MEMORANDUM

Subject: Rozenfeld Variance Request

3802 E Catamount Ridge Way [Community #30 - Granite]

BOA01172022-006252

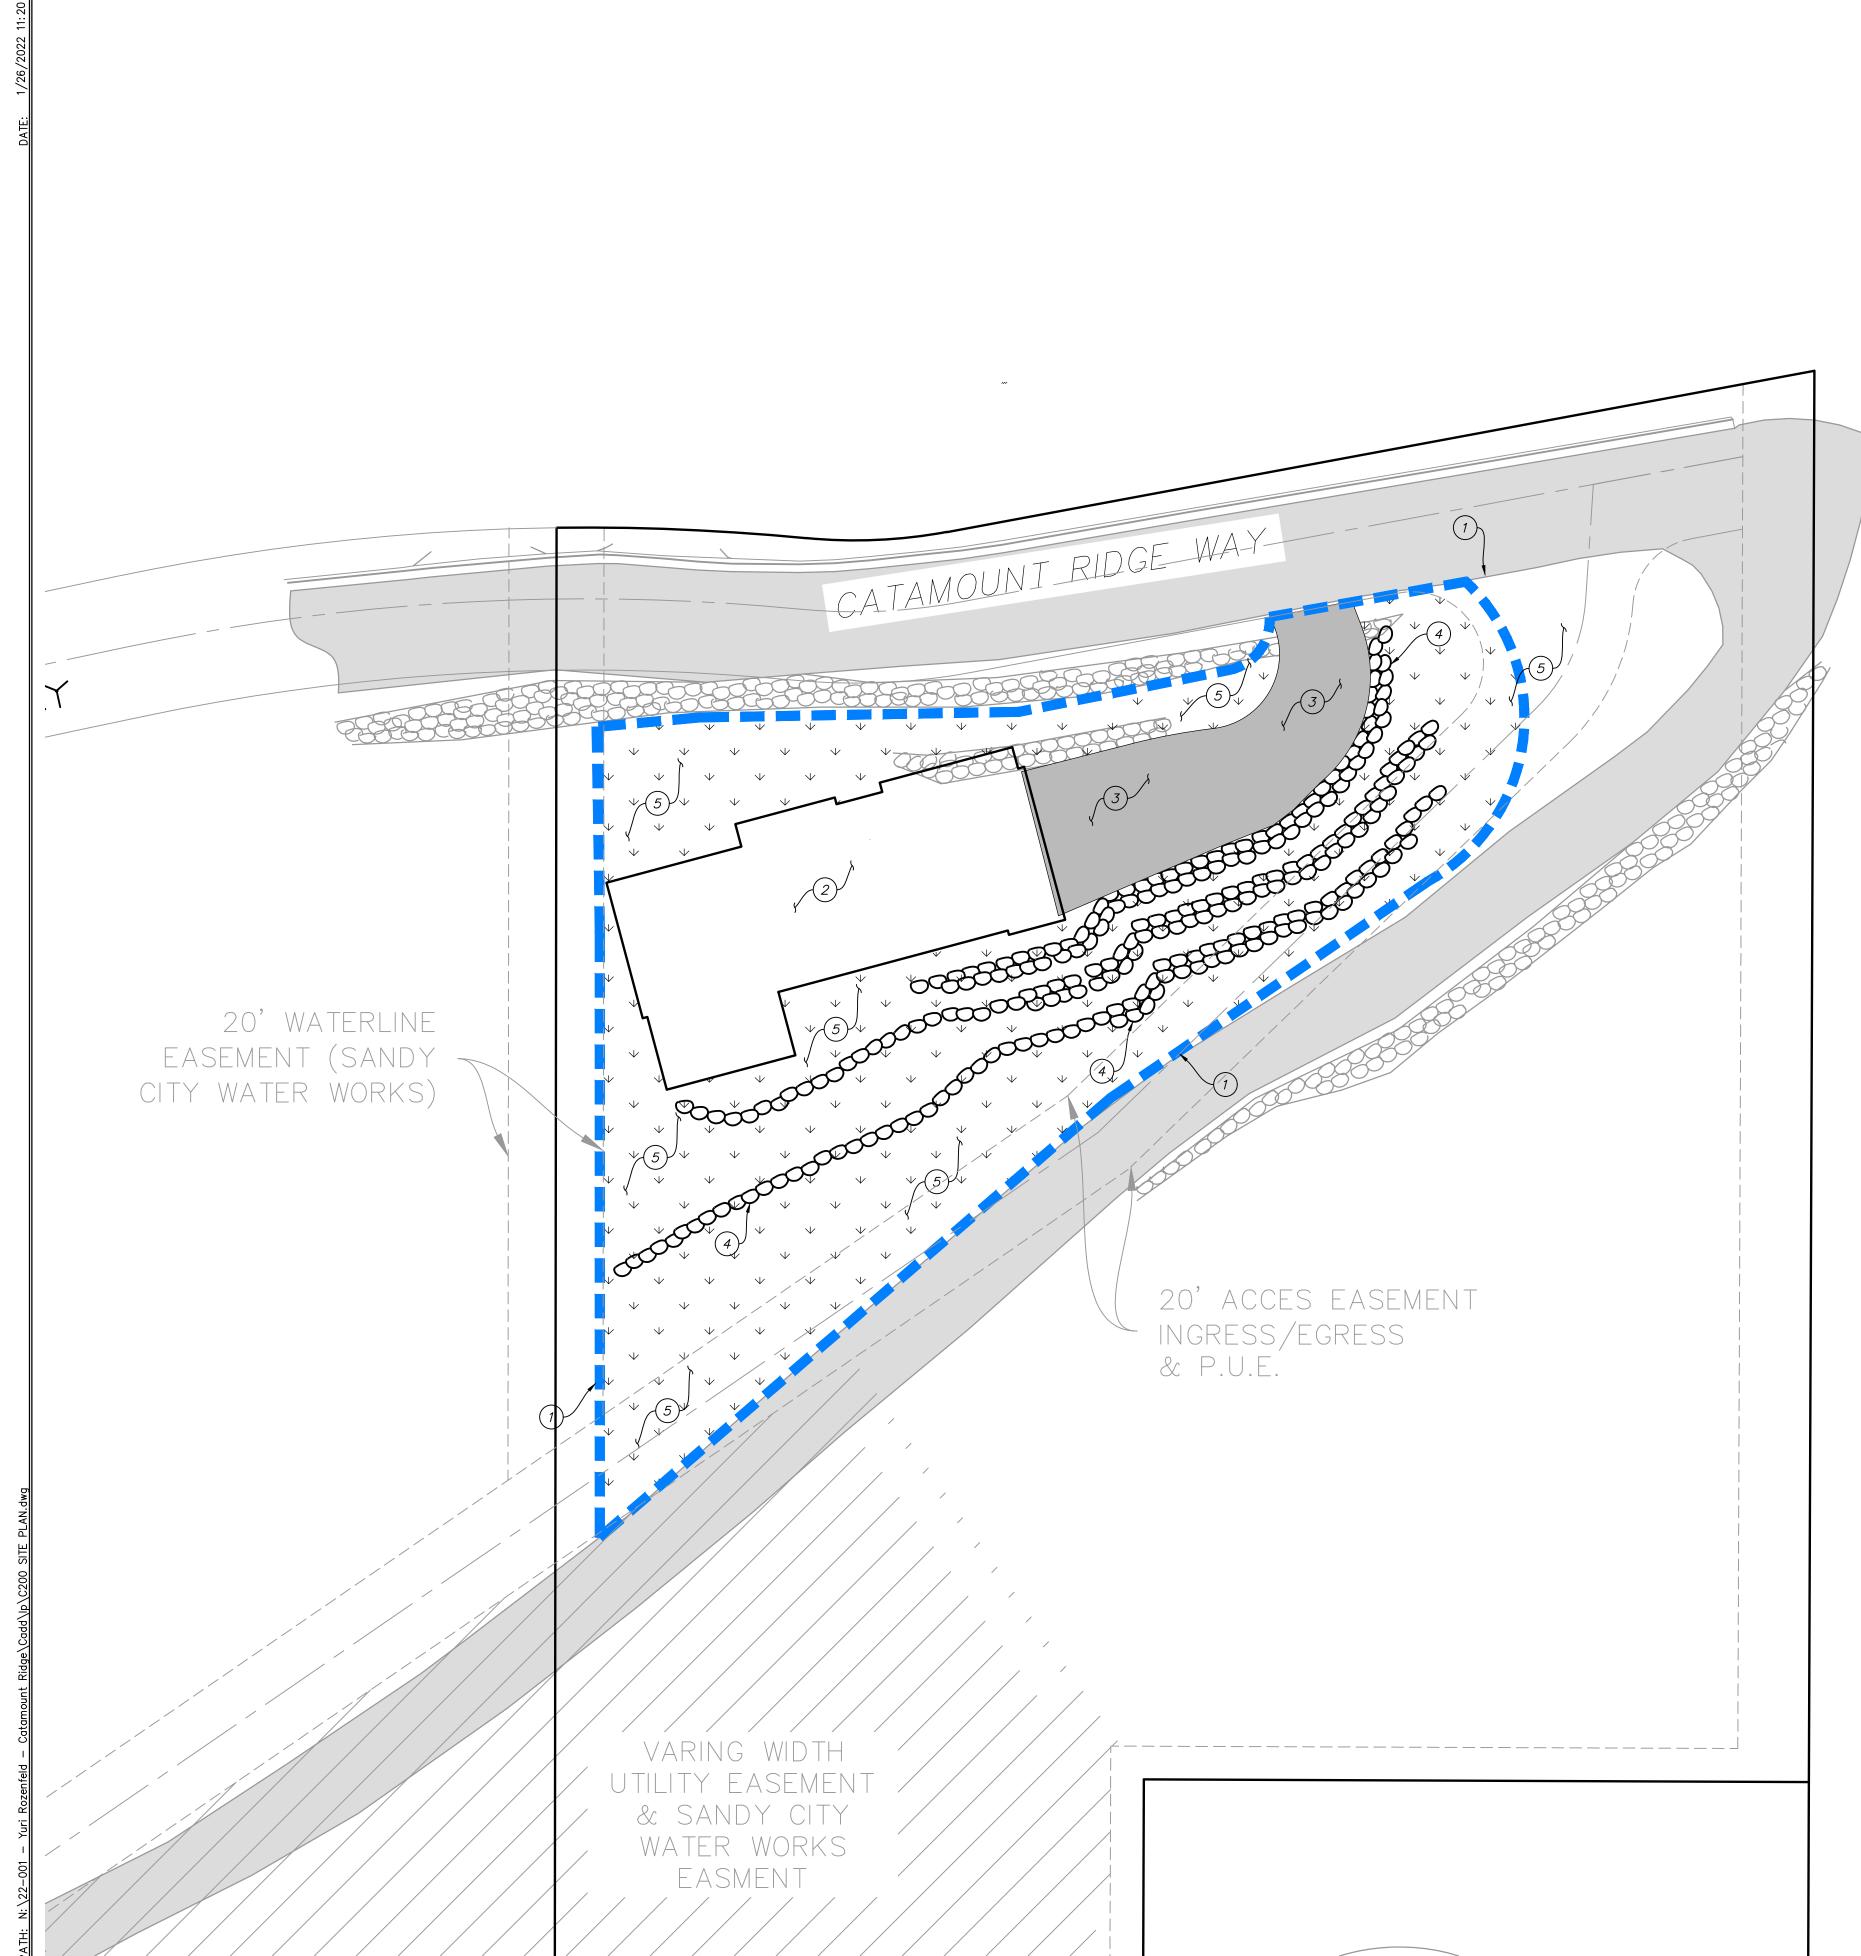
Staff is concerned with the overall area of disturbance shown in the applicant's preliminary site and grading plans. The area of disturbance is shown to be about 19,000 sq. ft. This appears to be too large and could be reduced if the applicant makes some adjustments to their plans. Part of this large disturbance area is due to the size of the home, size/orientation of the garage and driveway, desire to have some flat yard area/covered patio in the rear of the home, and overall orientation of the home.

- **#1 Footprint.** The proposed home is just above the minimum footprint of single level home (approximately 1436 sq. ft. on the main level), yet the garage is more than double the minimum required square footage (1019 sq. ft.) for a total building footprint of 2,455 sq. ft. Adjacent homes in the area on average are over 3,500 sq. ft. footprint, but those homes are not located on as steep of land with as many restrictions. In no case is the Board required to allow a home above the bare minimum home size for the zone. However, the Board can consider imposing a maximum home size to limit the impacts to the native area.

- **#2 Garage and Driveway.** The proposed home is proposed to have a side loaded garage rather than fronting the garage directly to the street and being placed below the living areas of the home. This design choice increases the overall area of disturbance. The width of the driveway also creates the need for higher and more retaining walls to meet maximum driveway slopes. At minimum, staff would suggest limiting the width of the driveway, to reduce the height of retaining walls and reducing the area of disturbance.

- **#3 Patio/Yard.** The home is currently designed with a flatter area behind the home with a covered patio area. By including this in their plans, it increases need for retaining walls and increases the overall disturbance area. The Board may want to limit area of disturbance outside the footprint of the home to only allow for construction of the home and not to create a usable yard area.

- **#4 Orientation.** The home is not quite fully aligned or oriented with the existing contours. It could be further rotated counterclockwise to align with the contours more closely. The disadvantage of that rotation would be that it increases the distance from the road of area that needs to be disturbed but reduces the size of retaining walls. Alternatively, the home could be rotated clockwise and oriented to the street and sited closer to the road rather than further up the hillside. It would reduce the area of disturbance but might increase some cuts/fills and retaining walls on the lot.

- 1. All proposed retaining walls be designed to follow the City Engineer's recommendations, including rock fall mitigation measures.
- 2. If the development of the dwelling as proposed creates cuts and fills over 10 feet in height, that they seek a special exception from the Planning Commission prior to issuance of a building permit.

- 3. That the Planning Commission review a detailed grading plan of the lot prior to issuance of a building permit which shows the proposed grading, cuts, fills, or terracing on the continuous hillside of 30% or greater slope.

- 4. That a vegetation plan, in accordance with Development Code Section 21-15-4(b)(3) be reviewed and approved by staff prior to issuance of a building permit to ensure the disturbed areas of the lot are properly restored, and drainage and slope stability issues are mitigated.

- 5. That the proposed home be allowed to be constructed to a footprint no larger than 2,455 square feet (including the garage area) in order to reduce the impact to the hillside and reduce the amount of disturbance to the natural vegetation.

- 6. That the area behind the home and driveway that is to be disturbed to construct the home be limited to an average of twenty feet (20'). That a limit of disturbance be placed at the existing 5420' elevation contour in order to reduce the impact to the hillside and reduce the amount of disturbance to the natural vegetation.

- 7. That the driveway width be limited to eighteen-foot (18') maximum and a depth of at least twenty feet (20') before tapering to a minimum twelve foot (12') wide drive approach in order to reduce the impact to the hillside and reduce the amount of disturbance to the natural vegetation.

8. That all reports, plans, studies, and reports required by the City Engineer and Section 21-15, Sensitive Area Overlay be completed prior to issuance of a building permit and approval of an engineered site plan.
